ITEM 30

CONCEPT PLAN REVIEW FOR CLOVERCROFT ESTATES SUBDIVISION, CONTAINING 40 LOTS ON 204 ACRES LOCATED OFF CLOVERCROFT ROAD IN THE 4TH VOTING DISTRICT (1-2025-211).

| File Number | (1-2025-211) | |

NRP 3 SLOPES EXHIBIT

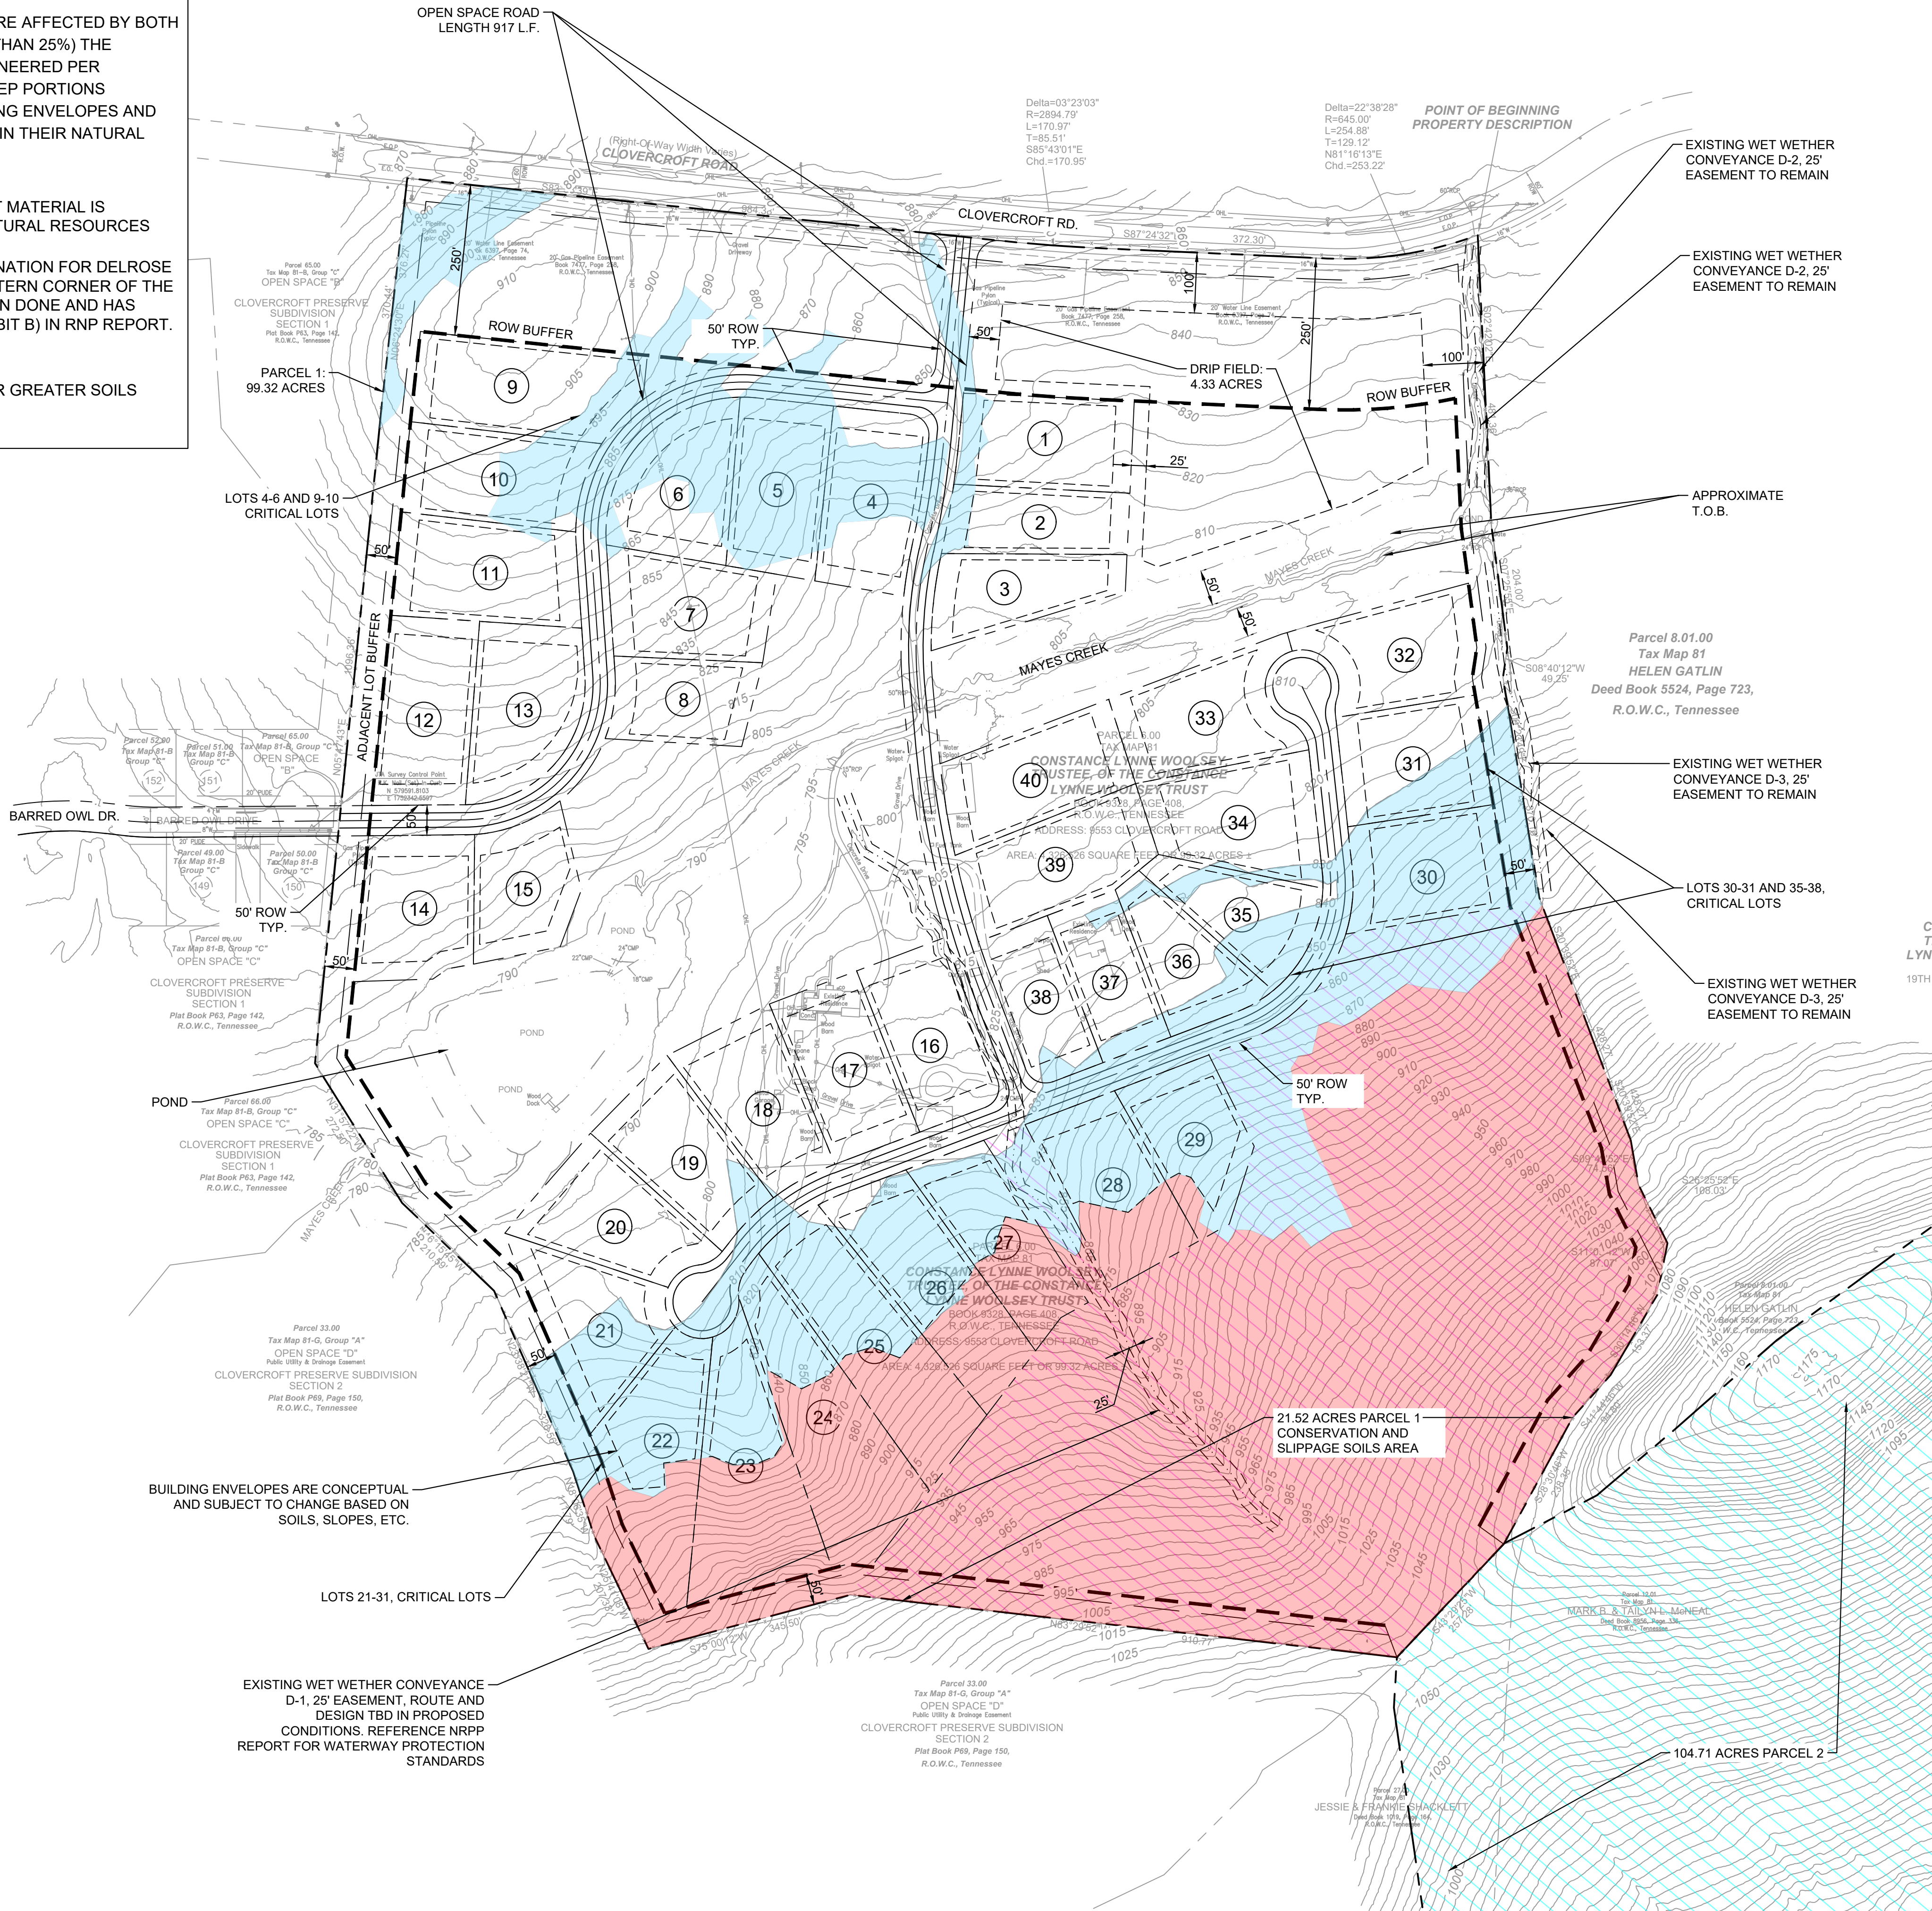
Furthermore, after Staff reviewed the submitted Natural Resource Protection Plan, it was noted that at least eight (8) of the lots contain slopes in excess of twenty-five (25%) percent. Article 13 of the Zoning Ordinance requires these slopes to be located in Open Space (See Attachment 30-5).
